WARD REPORT on the

*S S Kingsbury*

N<sup>o</sup> 3 Hatchway or Bridge D<sup>th</sup>

*on Newcastle  
report  
28/10/32*

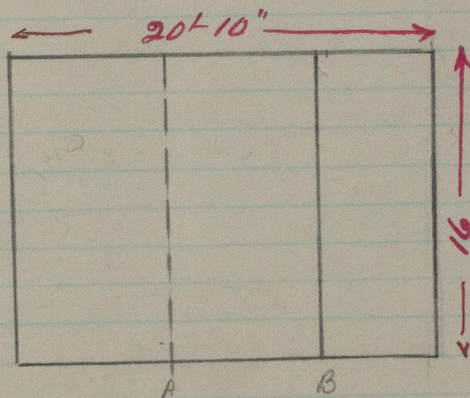
*From report it is not  
clear whether A or B is  
the division beams.  
over wellhead*

assuming 12 ft length  
& one beam.
